Access Compliance Report

Public Rights-of-Way

(Curb Ramps)

Intersection ID: 32252	Main Street: BRYANT_FARMS_RD	Cross Street: BALMORAL_PARK_DR	Location: W
ADA ID: 3332343A16F5	Ramp Type: Perp	Initial Pass/Fail: Fail	Overall Compliance: No
Severity Score: 33.75			
Codes/Mitigation Info/Possible Solution		Field Measurements/Component Compliance

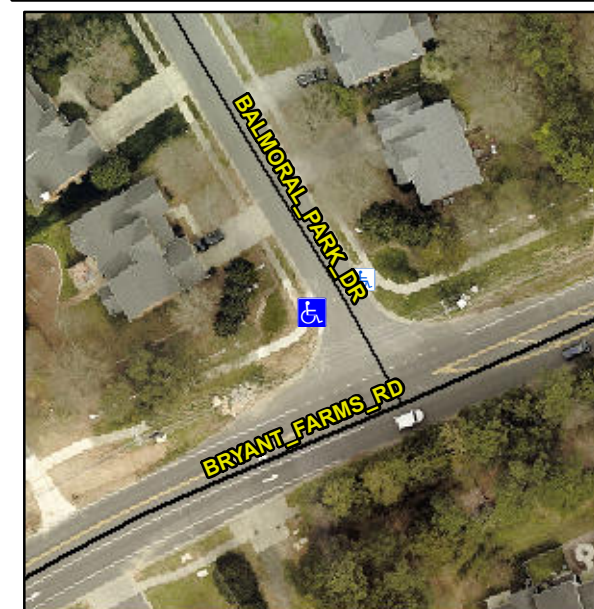
Not Found, R304.5.1, R304.2.2, R304.5.3

Compliance	Description	Data	Compliance	Description	Data
N/A	Ramp Length (in)	56.0	No	Ramp Slope (%)	9.2
No	Ramp Width (in)	46.0	No	Ramp XSlope (%)	5.2
N/A	Flare Type LT	N/A	N/A	Flare Type RT	N/A
N/A	Flare Slope LT (%)	N/A	N/A	Flare Slope RT (%)	N/A
N/A	Flare Traversable LT?	N/A	N/A	Flare Traversable RT?	N/A
N/A	Landing Length (in)	N/A	N/A	DWS Provided?	N/A
N/A	Landing Width (in)	N/A	N/A	DWS Contrast?	N/A
N/A	Landing Slope (%)	N/A	N/A	DWS Length (in)	N/A
N/A	Landing X Slope (%)	N/A	N/A	DWS Full Width?	N/A
N/A	Landing Curb? (Y/N)	N/A	N/A	DWS Offset (in)	N/A
N/A	Shared Landing?	N/A			
N/A	Gutter Ponding?	N/A	N/A	Gutter Slope (%)	N/A
N/A	Gutter Lip Ht (in)	N/A	N/A	Gutter X Slope (%)	N/A
N/A	Painted X Walk1?	No	N/A	Painted X Walk2?	N/A
	X Walk 1 Direction	To E		X Walk 2 Direction	N/A
N/A	X Walk 1 Width (in)	N/A	N/A	X Walk 2 Width (in)	N/A
	X Walk 1 Slope (%)	7.1		X Walk 2 Slope (%)	N/A
	X Walk 1 X Slope (%)	3.0		X Walk 2 X Slope (%)	N/A

Remove & Replace Entire Ramp.
